Z-21
(2009)

SITE PLAN FOR
JAYESH T. SHETH

ZONING DIVISION COMMENTS:

STAFF RECOMMENDATIONS

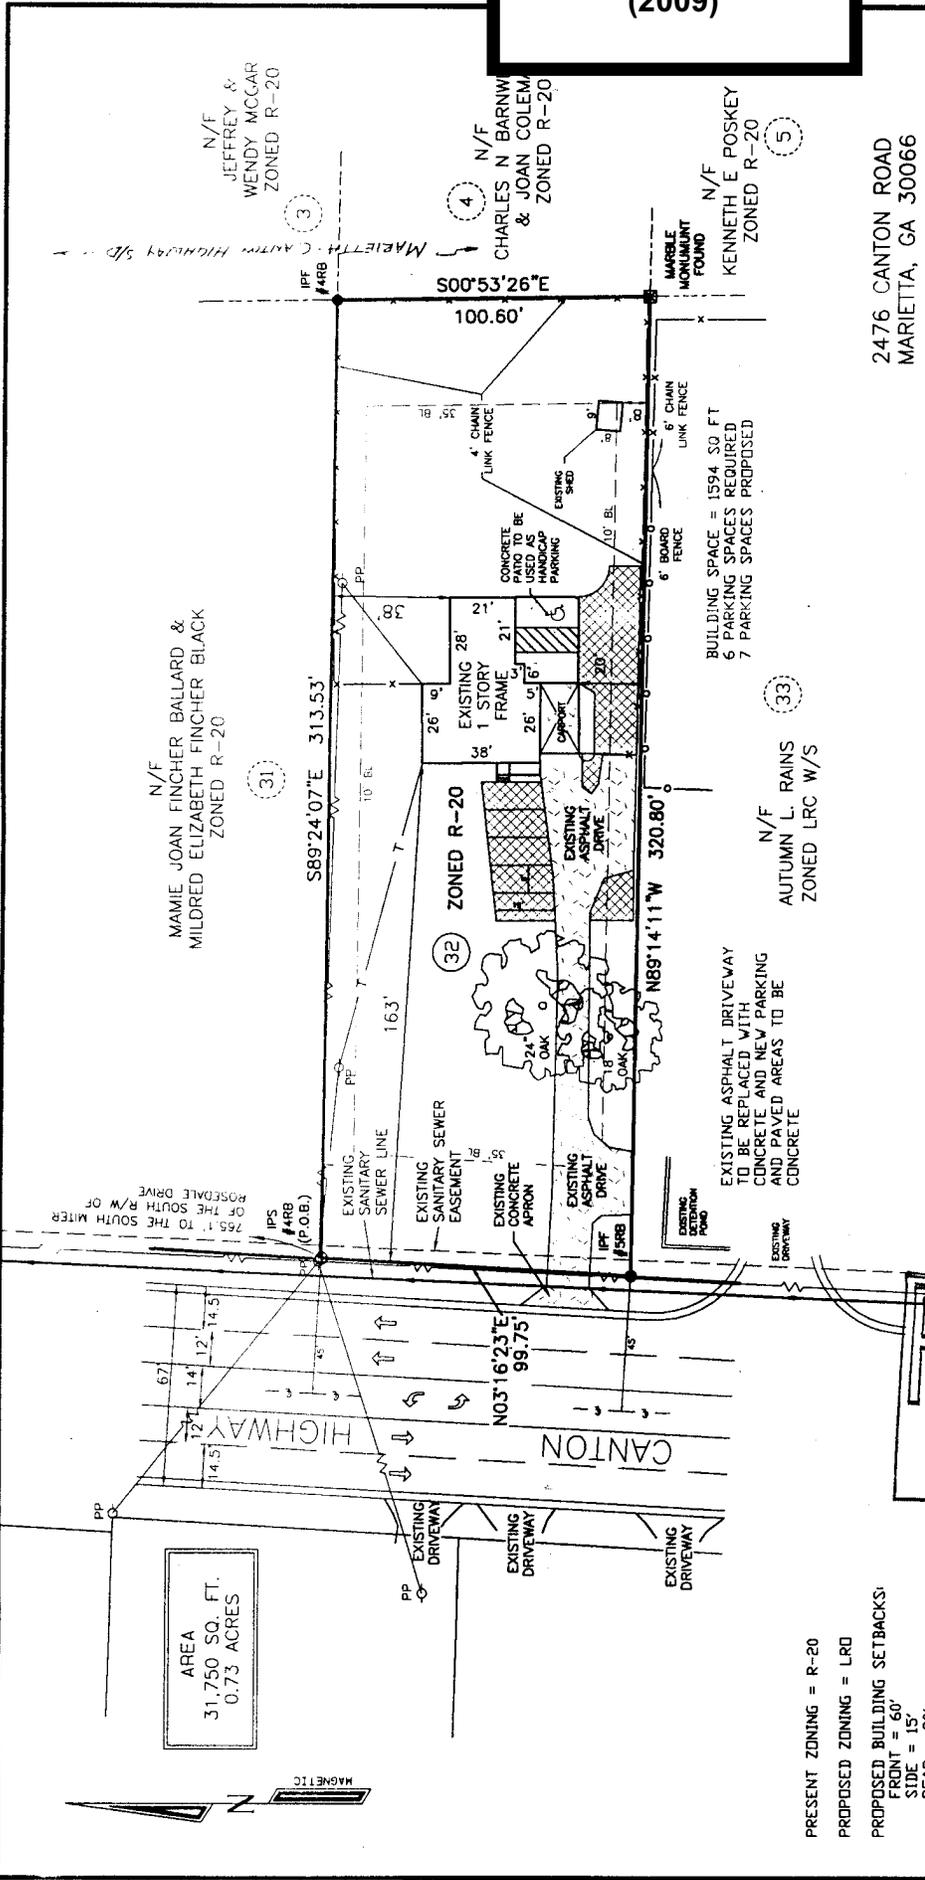
1. The proposed medical office use will require additional pavement to meet the parking requirement as indicated on the proposed site plan. The additional impervious area does not exceed the threshold for requiring detention and water quality, however, it is recommended that a stone filter strip be installed along the downstream edge of the proposed parking area. Since the existing driveway will be replaced, the undersized driveway culvert should be replaced as well to adequately accommodate upstream flows.

Install sidewalk along the road frontages.

Proposed driveway shall be built to Cobb County commercial standards.
